MIL-L-7082D
AMENDMENT 3

4 August 1978
SUPERSEDING
AMENDMENT 2
25 August 1971

LIGHT, RUNWAY MARKER, ELEVATED, TYPE M-1

This amendment forms a part of Military Specification MIL-L-7082D, dated 2 January 1969, and is approved for use by all Departments and Agencies of the Department of Defense.

FIGURE 2. Fixture assembly

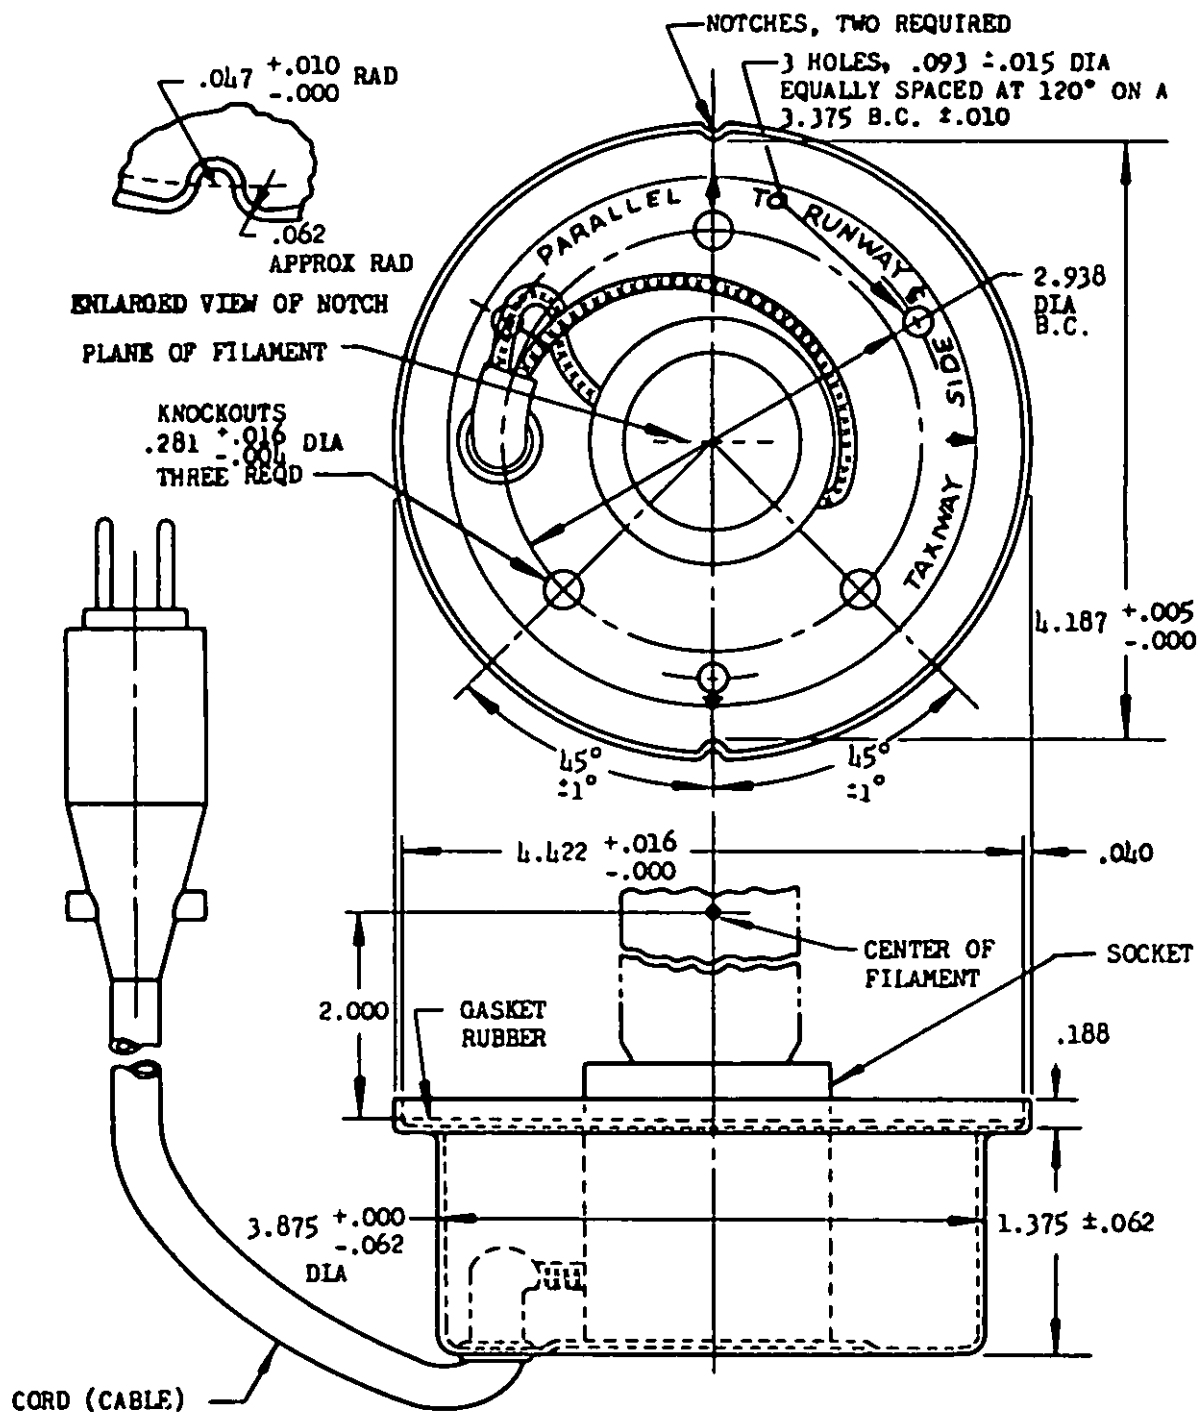
Delete Figure 2 and substitute attached Figure 2.
